UNITED STATES PATENT AND TRADEMARK OFFICE

APPLICATION NO.	FILING DATE	FIRST NAMED INVENTOR	ATTORNEY DOCKET NO.	CONFIRMATION NO.
10/784,454	02/23/2004	Dennis Conklin	4281-A11	8216

Office Action Summary

DETAILED ACTION

FIG. 2

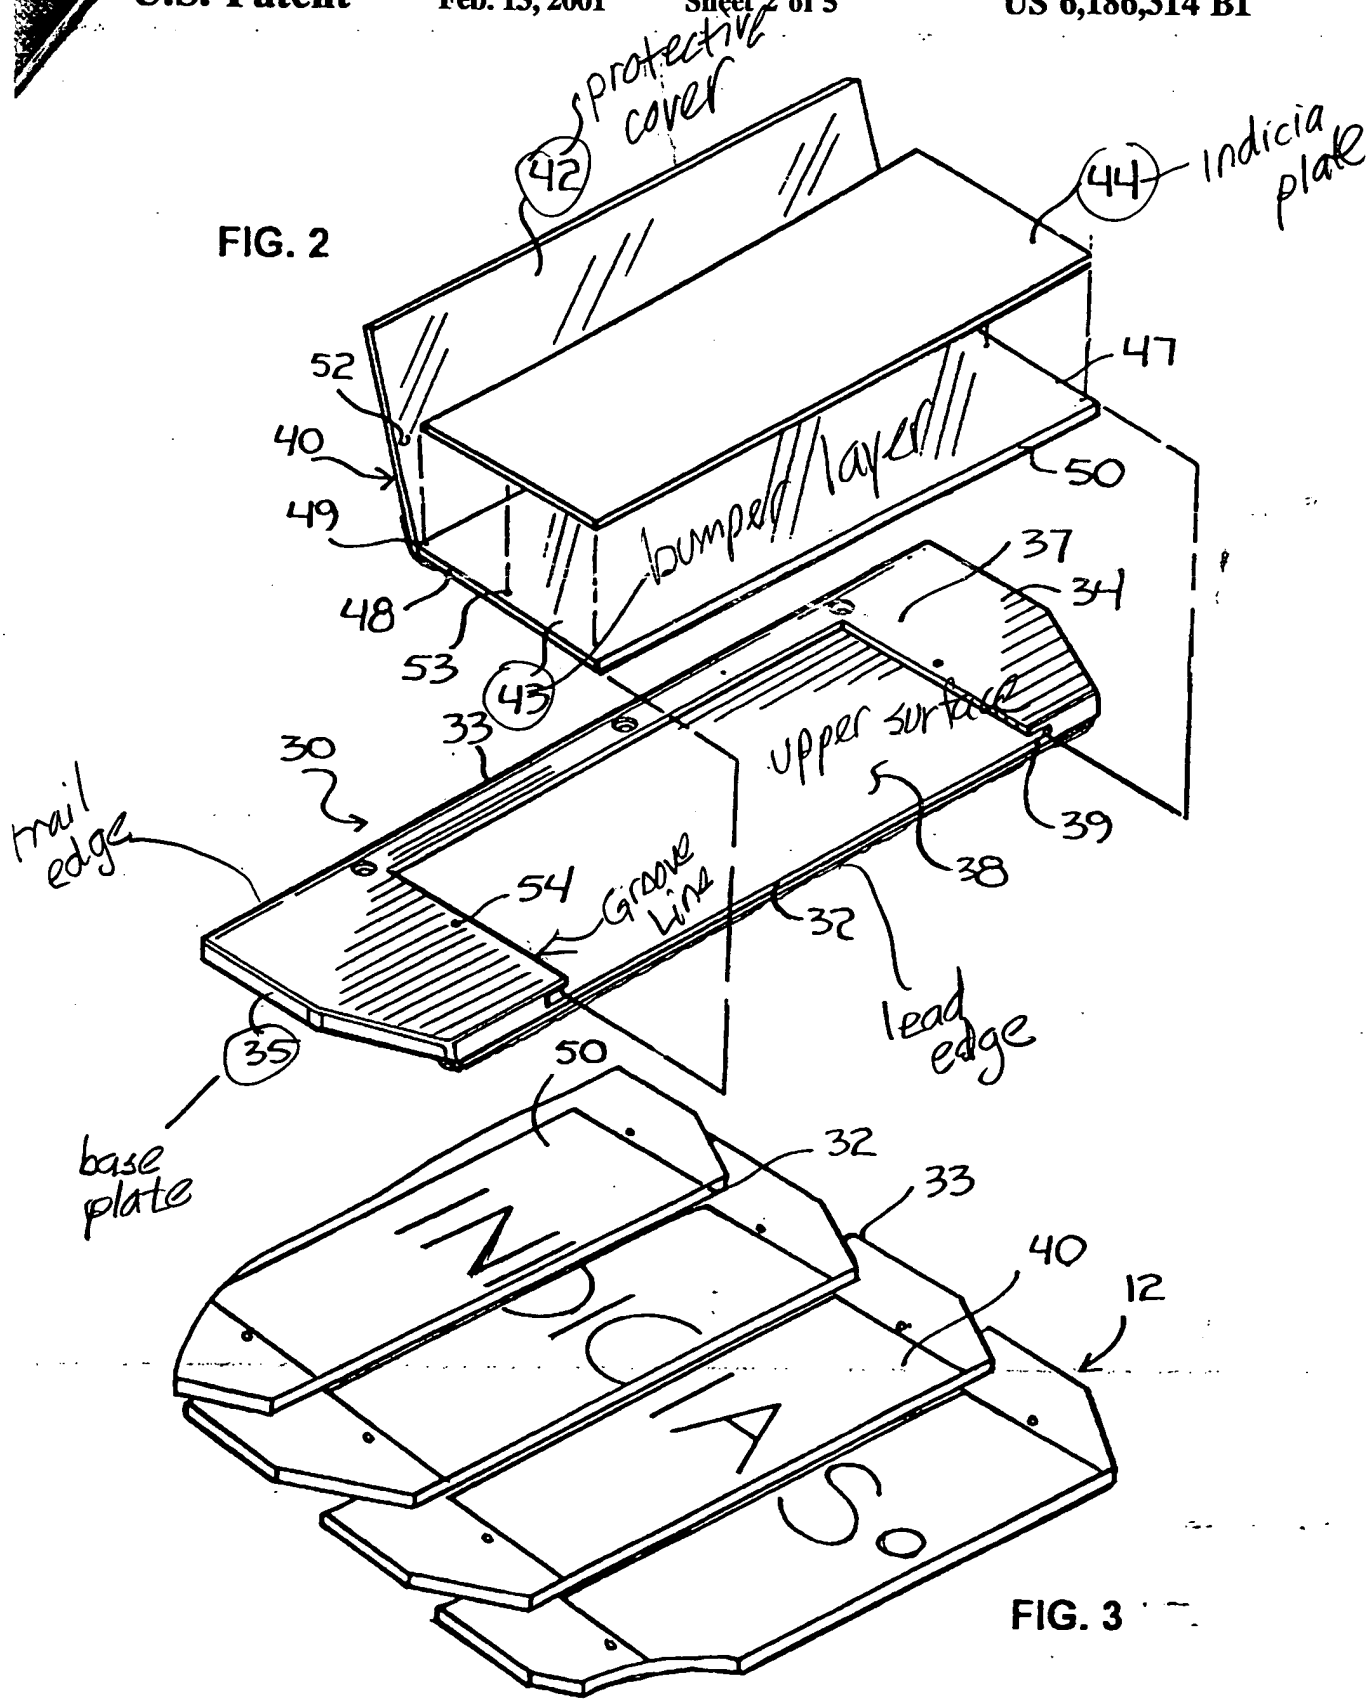
10. Claims 7, 11-13, 16, and 19 are rejected under 35 U.S.C. 102(e) as being anticipated by Conklin, Jr. (US Pat. 6,186,314).

See the attached marked up drawing figure 2 of Conklin, Jr. depicting the claimed features.
